City of Surrey PLANNING & DEVELOPMENT REPORT File: 7911-0112-00

Planning Report Date: July 25,2011

PROPOSAL:

in order to permit the development of a 3-storey office building and a retail commercial building.

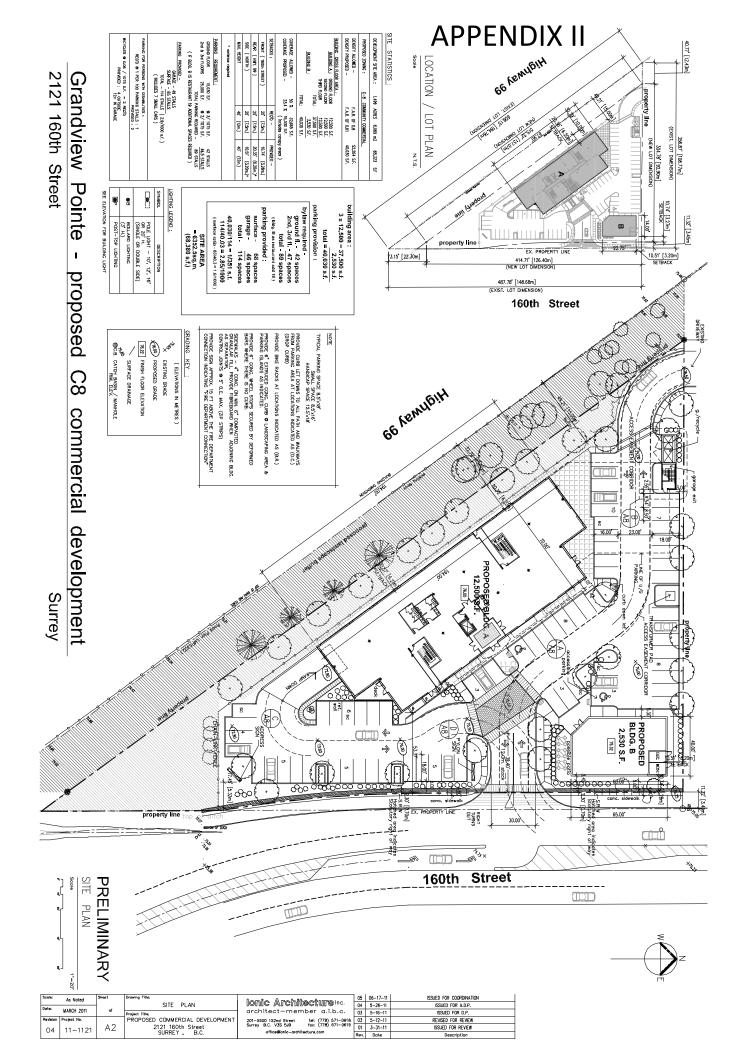
- Sidewalk heavily pinched on north east corner of building. Should retain a minimum sidewalk width of 5 feet at building corner.
- Consider locating commercial entry doors with provision for canopies on the main east face of the three storey building.

- Look at moving underground parking access to north rather than south. Current entry is very tight turn.
- Parking if you get a retail tenant and have a patio space at south corner of the building, the corner into the parking entrance here is too tight. Put underground parking access elsewhere to free up that corner for other uses.
